Record Detail * (This section is required.)

Permit Type	Permit Number	Opened Date
Building/Residential/Misc/Tanks	B22004297	11/18/2022
Description of Work		
SFD/INSTALL (1) UNDERGROUND 500 PROPANE TANK

11/22/22 - email to Lou Ann @ Dixie Land Nrg requesting a revised plan meeting the septic setback

PLAN VIEW
1" = 50'

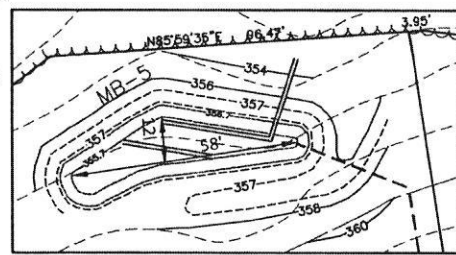
See revised plan

Tank 16x4
15' off house
60' off Septic - no sept back
30' off Right
100' off Front
67' off left
142' off Rear
60' off well

PLAN VIEW

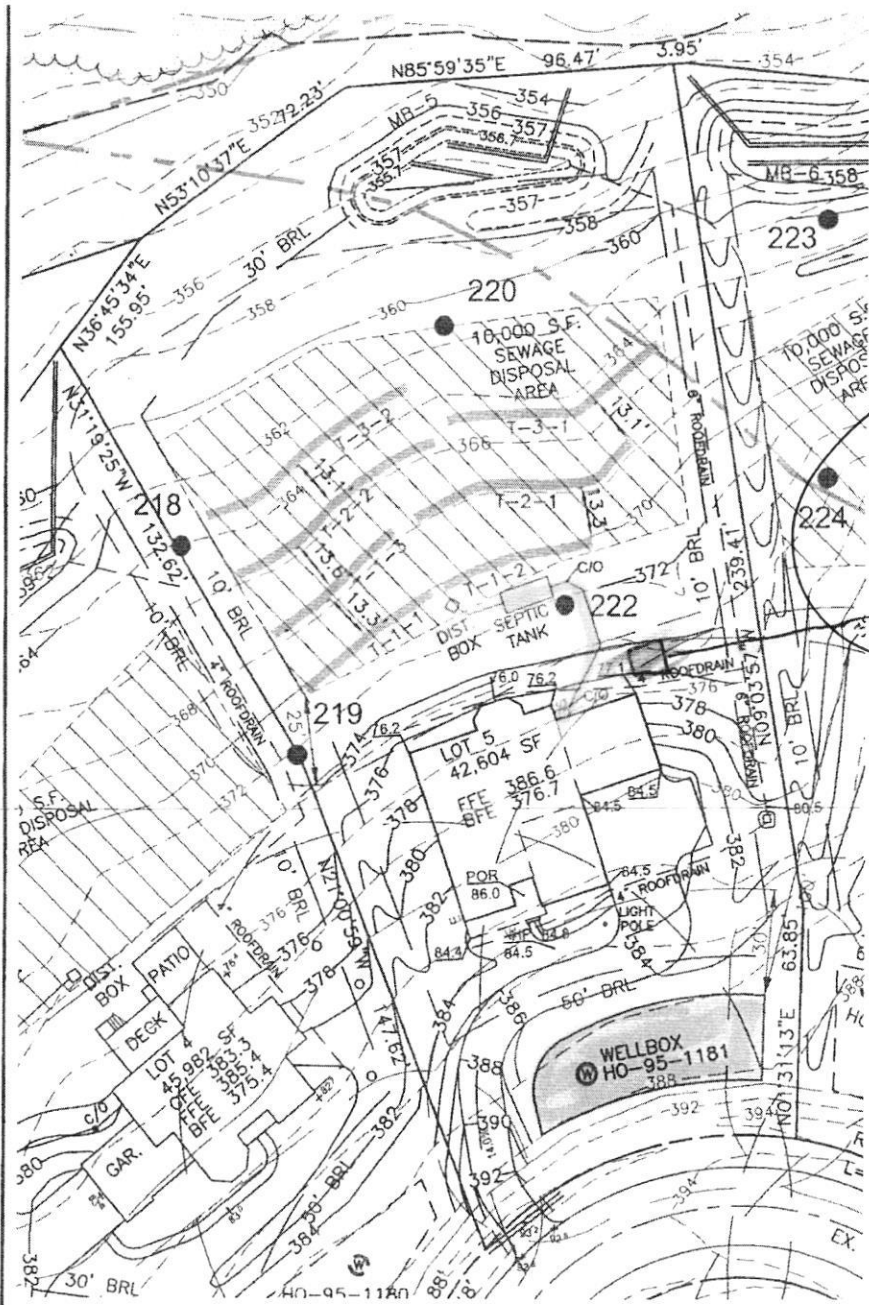
Tank 16' x 4'
 15' off house
 60' off Septic
 30' off Right
 100' off Front
 67' off Left

(IN FEET)
 1 inch = 50 ft
 142' off Rear
 65' off Well

Approved for
 LP tank
 B22004297C
 12/5/22
 Proposed tank
